# Product Change Notification

## 112433 - 00

**Change Notification #:** 112433 - 00  
**Change Title:** Intel® Server Chassis P4304XXSFCN  
PCN 112433-00, Product Design, Label  
Update Power Supply Cables, Package  
Regulatory Label with Perchlorate Statement,  
Common Regulatory Label, and Front Panel  
Power Button Tube Material  
**Date of Publication:** July 15, 2013

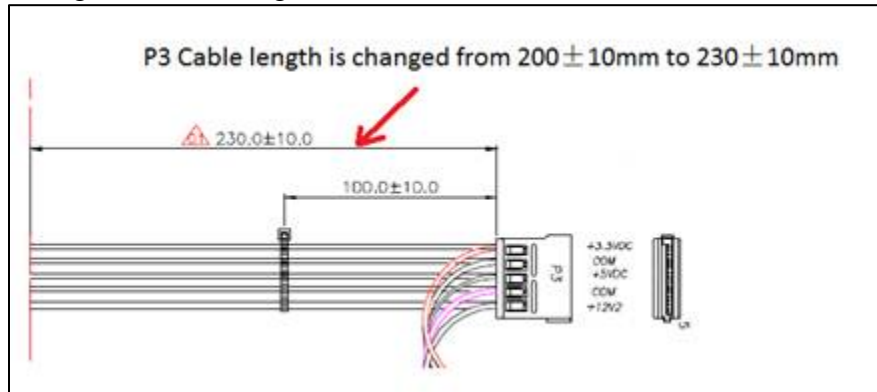
1. The cables on the power supply are being changed from E95763-005 to E95763-006 to improve connect ability. The following changes will apply:
  - a) Change the cable length of P1 from 170mm to 290mm:

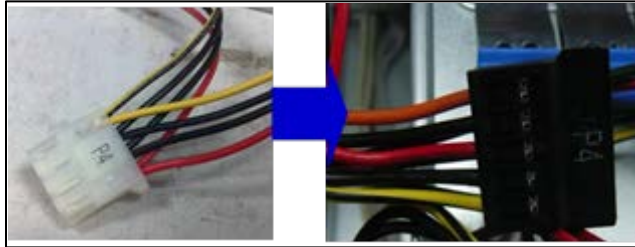
- b) Change the cable length of P3 from 200mm to 230mm:
